P-15773

**JINDAL ALUMINIUM LTD.**  
 BANGALORE-560073 (INDIA)

PARTY'S NAME	LITWEL INDIA LTD., DELHI
PARTY'S DRAWING No.	AS PER DRAWING
ALLOY & TEMPER	HE9 WP
DESCRIPTION	ROUND HEAT SINK SECTION

S4925

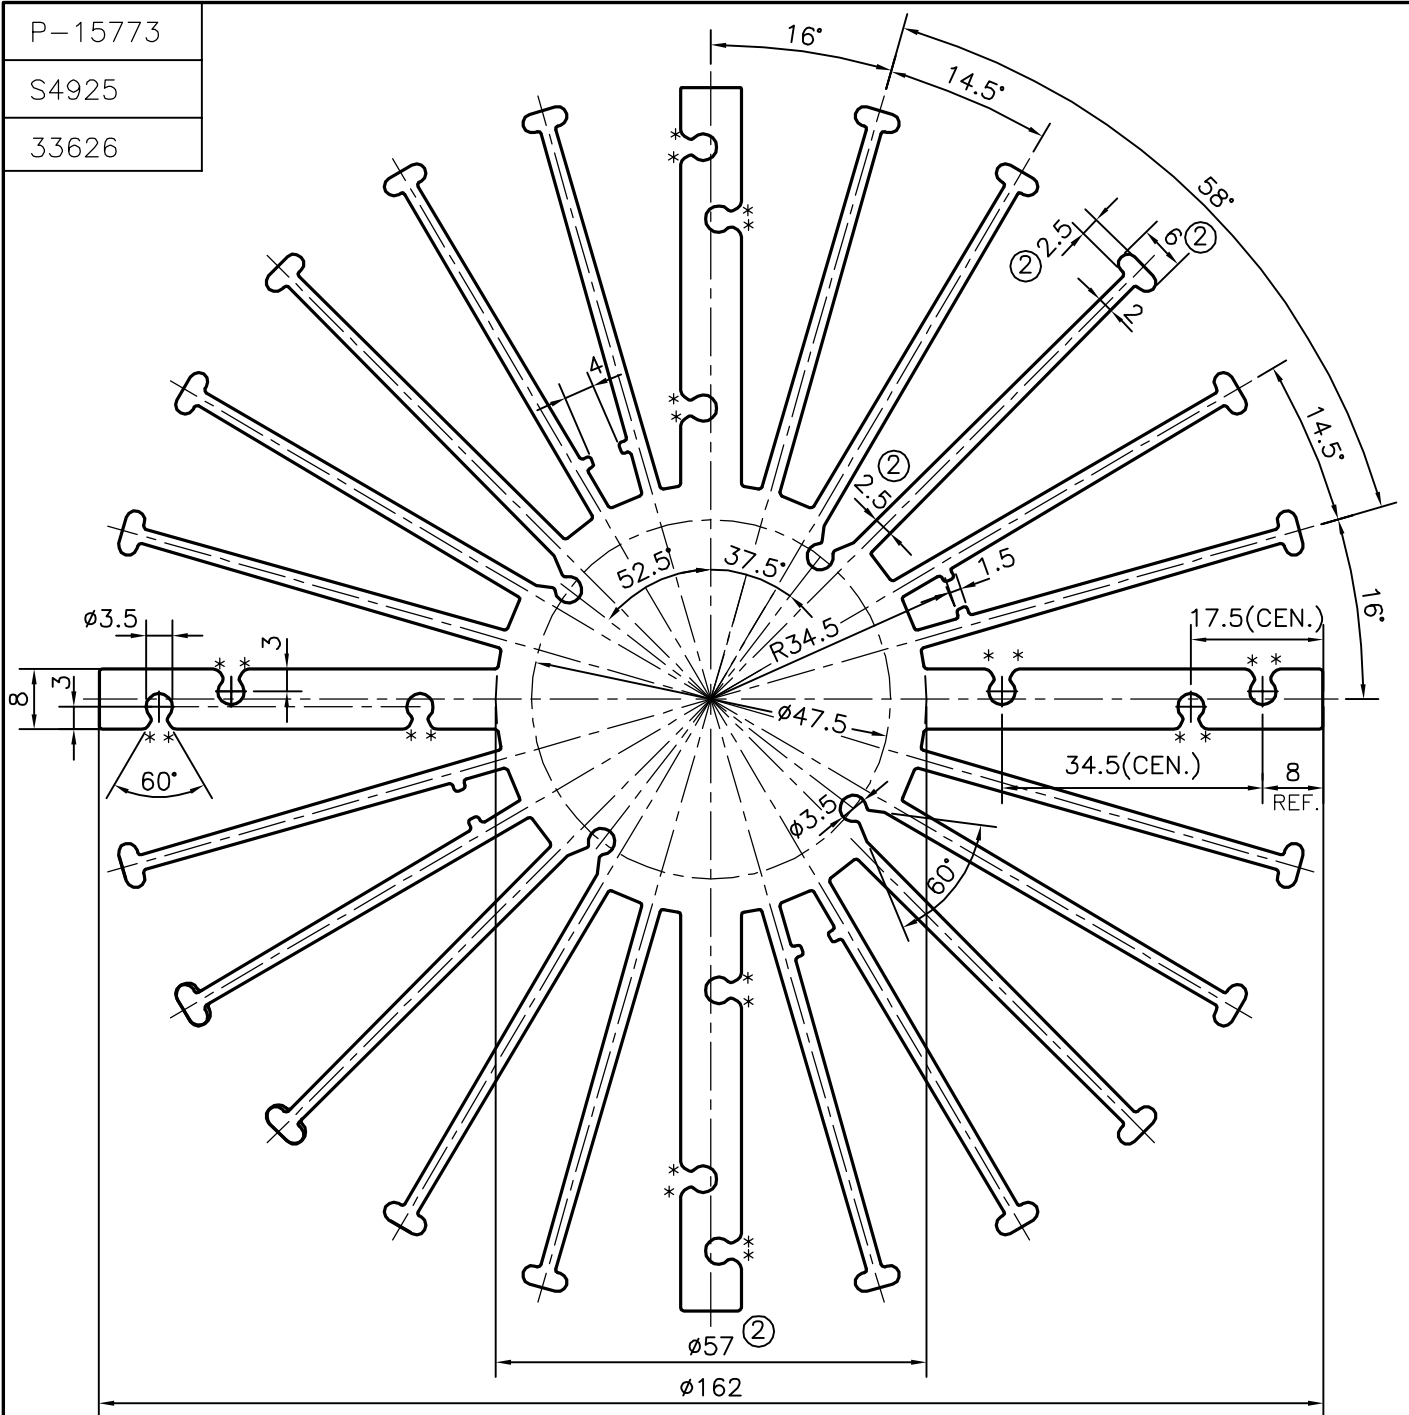
ISSUE-2 (2)  
 DIMENSIONS CHANGED FROM  
 52.5 TO 57.00  
 5.00 TO 6.00  
 2.00 TO 2.50mm &  
 WEIGHT ALSO CHANGED FROM 16.306 kg/M TO 17.634 kg/M
